## STAFF RECOMMENDATION 2014 Cedar Lane November 18, 2015

**Application:** Demolition; New construction—Infill and outbuilding; Setback determination

**District:** Belmont-Hillsboro Neighborhood Conservation Zoning Overlay

**Description of Project:** Application is to demolish the existing multi-family structure and construct a new multifamily structure with six units and an outbuilding that contains one unit. The outbuilding requires a reduction to the rear setback.

Figure 1. 2014 Cedar Lane.

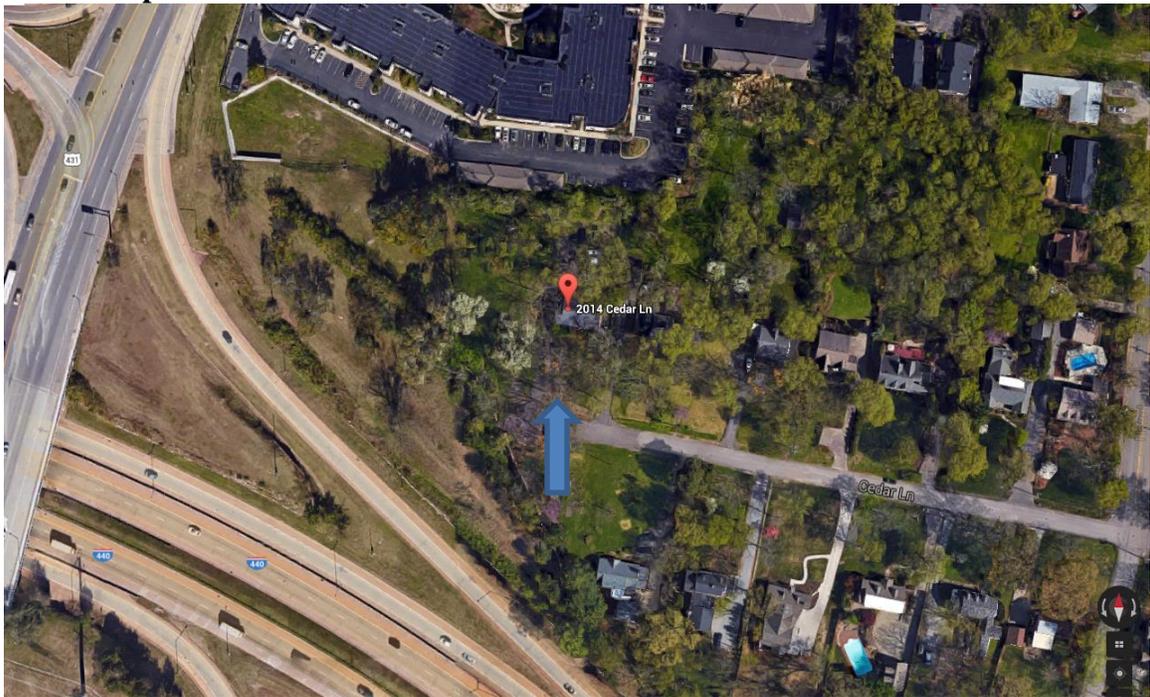
**Background:** The existing structure at 2014 Cedar Lane was constructed c. 1950, and is non-contributing (Figure 1). The lot is over sixteen thousand square feet (16,000 sq. ft.), and is zoned RM20, which allows for seven residential units on the lot. The lot abuts Interstate 440, and it marks the edge of the Belmont-Hillsboro Neighborhood Conservation Zoning Overlay.

**Demolition:** The existing structure at 2014 Cedar Lane was constructed c. 1950. Staff finds that its date of construction, materials, design, and lack of architectural details do not contribute to the historic character of the Belmont-Hillsboro Neighborhood Conservation Zoning Overlay. As such, staff finds that its demolition meets Section V.B.2. for appropriate demolition and does not meet Section V.B.1. for inappropriate demolition.

# OUTBUILDING/DADU WORK SHEET

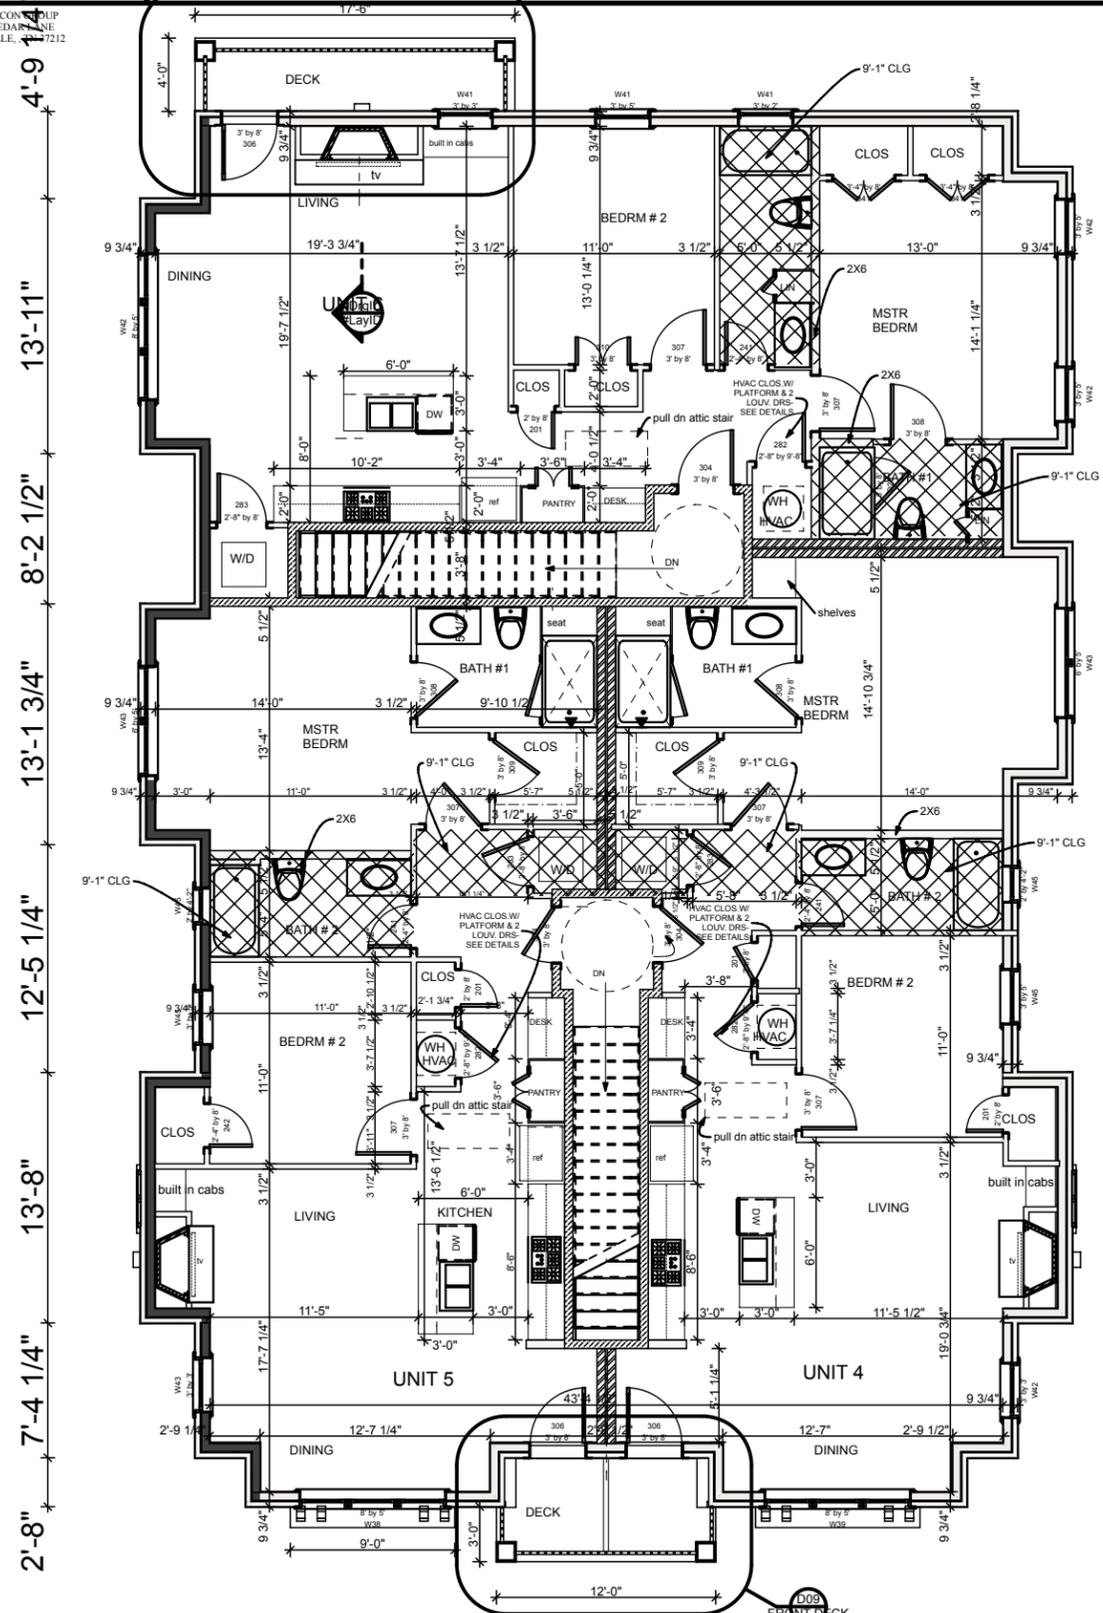
MINIMUM	PROPOSED
Space between principle building and DADU/Garage	20'	40'+
Rear setback	3'	10'
L side setback**	3'	7'
R side setback**	3'	14'
How is the building accessed?	From the alley or existing curb cut	Curb cut

Existing conditions (height of historic portion of the home to be measured from finished floor)	Potential maximums (heights to be measured from grade)	Proposed (should be the same or less than the lesser number to the right)
Ridge Height	32'	25'	24'6"
Eave Height	23'6"	1 story 10' or 2 story 17'	19'1"

Lot is less than 10,000 square feet	Lot is more than 10,000 square feet	40% of first floor area of principle structure	Proposed footprint
Maximum Square Footage	550 sq. ft.	1,000 sq. ft.	1810 sq. ft.	1,130 sq. ft.

Outbuildings: See attached "Outbuilding Worksheet" for a full analysis of the appropriateness of the proposed outbuilding. The outbuilding will have a footprint of one thousand, one hundred, and thirty square feet (1,130 sq. ft.). This is larger than what is typically approved, but staff finds it to be appropriate for several reasons. The site is unusually large at over sixteen thousand square feet (16,000 sq. ft.) and appears even larger because of the right-of-way to the left. In addition, because the lot is zoned RM20, there are parking and fire requirements that are not typical of the single-family lots in the area.

Outbuildings with footprints greater than seven hundred square feet (700 sq. ft.) are required under base zoning to be twenty feet (20') from the rear property line. The applicant is proposing to place the outbuilding just ten feet (10') from the rear property

line. Staff finds the proposed setback determination to be appropriate because outbuildings historically were located near or on the rear property line. In addition, the ten foot (10') setback allows for more space in between the infill and the outbuilding and the lot backs up to a larger multi-family development rather than a single-family lot.
